**SUBJECT: COMMENTS ON DRAFT ENVIROMENTAL IMPACT REPORT (DEIR) FOR
METRO GOLD LINE FOOTHILL EXTENSION FROM AZUSA TO MONTCLAIR**

URBAN CROSSROADS, INC. TECHNICAL MEMORANDUM #1

METRO GOLD LINE PHASE II EIR REVIEW

Street Crossings

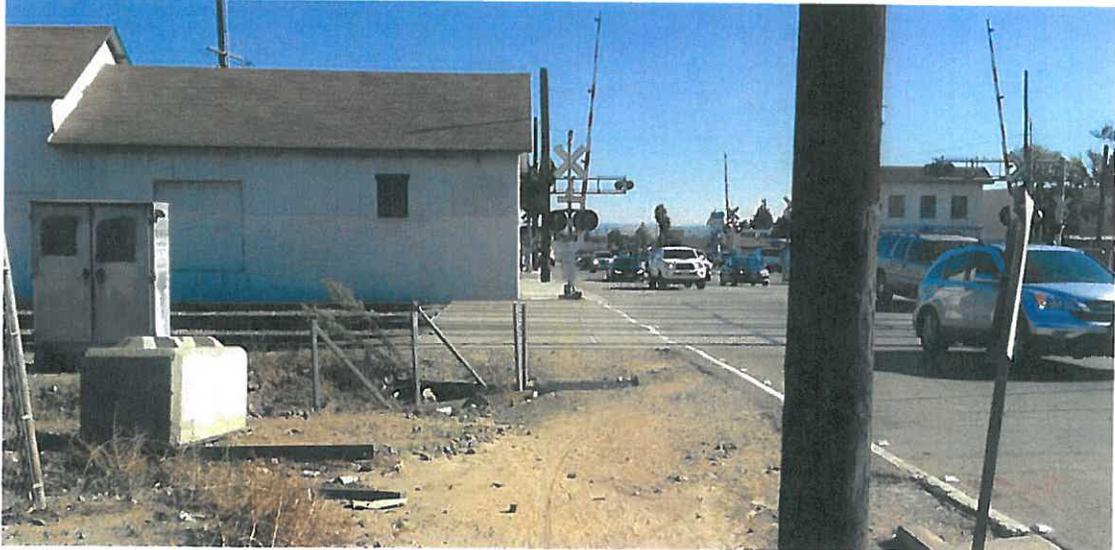
Existing at-grade street crossings are located at Fulton Road, Garey Avenue, and Towne Avenue. Fulton Road is a 2-lane road, while Garey Avenue and Towne Avenue are 4-lane roads. Each crossing has gates that control the automobile traffic when a train is using the crossing.

Pedestrian activity was observed at all three of the at-grade street crossings. A cyclist at the Fulton Road crossing is shown here:

Existing restriction to southbound pedestrian activity at the Towne Avenue crossing (on the west side):

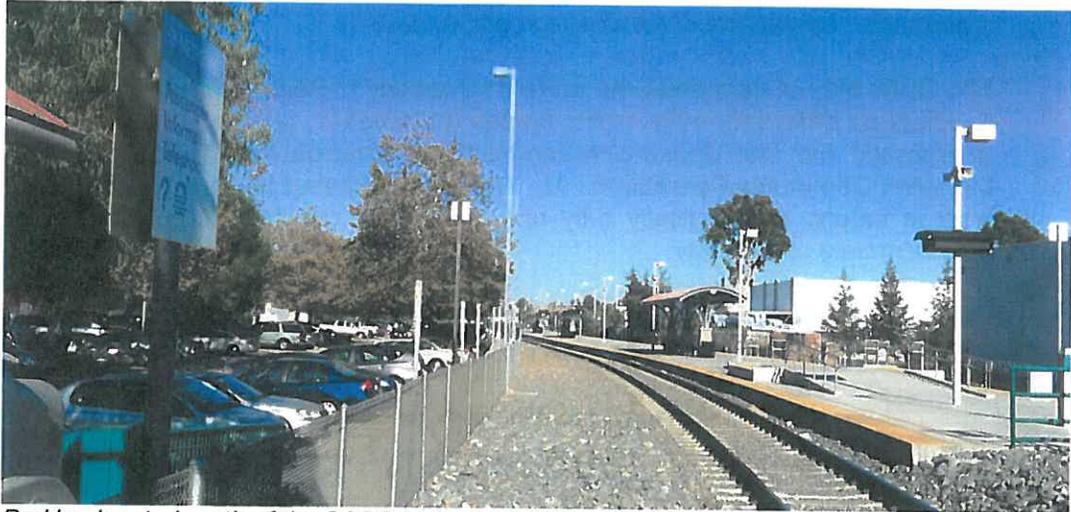
Pedestrian travel is constrained by existing power lines and limited sidewalk connectivity.
